SONET Definition for WIS

(some nits worth picking)

IEEE 802.3ae
May 25th, 2000
Ottawa, ON

OC-192c WIS - Overhead

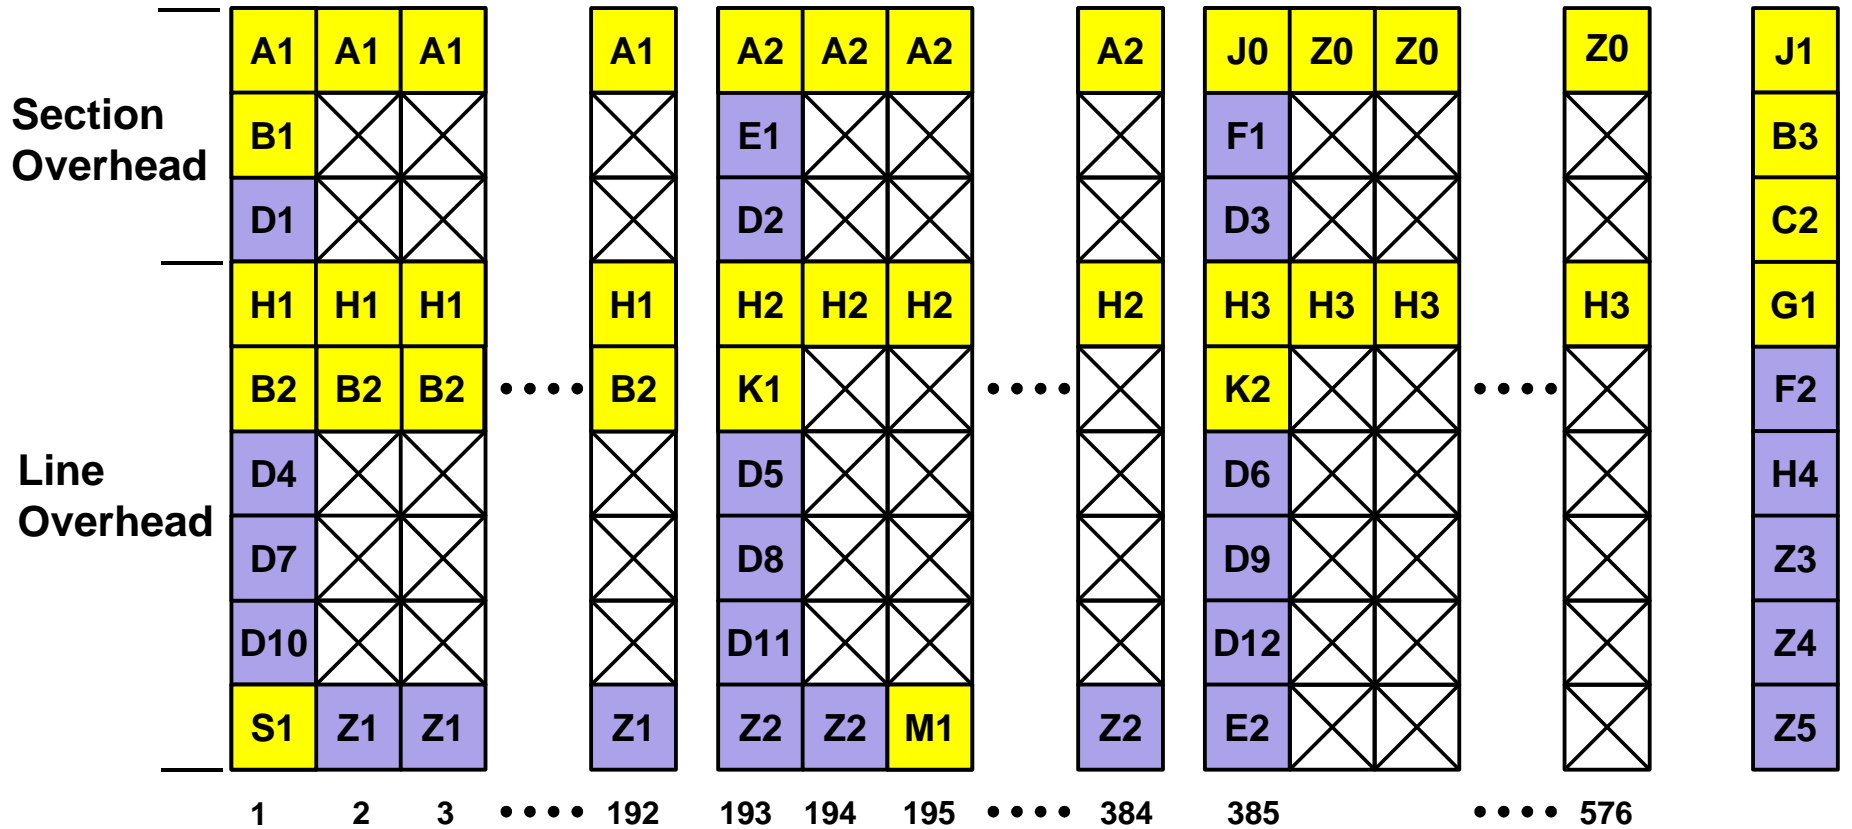
Our Recommendation

- **B1 - Bit Interleaved Parity is a single 8 bit value which is used to measure bit error rate**
- **At OC-192, B1 saturates so quickly that you cannot distinguish between BERs higher than 10^{-7}**
- **B1 is useful for fault isolation, but not for performance monitoring**

- **B2 is calculated per STS-1**
- **Since there is a separate B2 for each STS-1, there is a constant ratio of parity bits to data bits, regardless of the line rate**
- **The saturation point is constant at 10^{-4}**
- **Therefore, B2 is useful for performance monitoring**

- **Need to support B2 to maintain**
 - **Compatibility with other OC-192 interfaces (i.e. TDM, POS, etc)**
 - **Familiarity and consistency for crafts persons**
 - **Compatibility with existing test equipment**

- **Cost of supporting B2 entails:**
 - **192 8 bit registers in TX and RX**
 - **8 bit parity checker/generator can be shared across all 192 STS-1s**
 - **Also need a 32 bit accumulating counter in RX to report statistic to management system**

- **M1 provides remote error monitoring**
- **Reflects remote value of B2**
- **Cost of supporting M1 entails:**
 - **One 8 bit register in RX**
- **Provides same compatibility benefits**
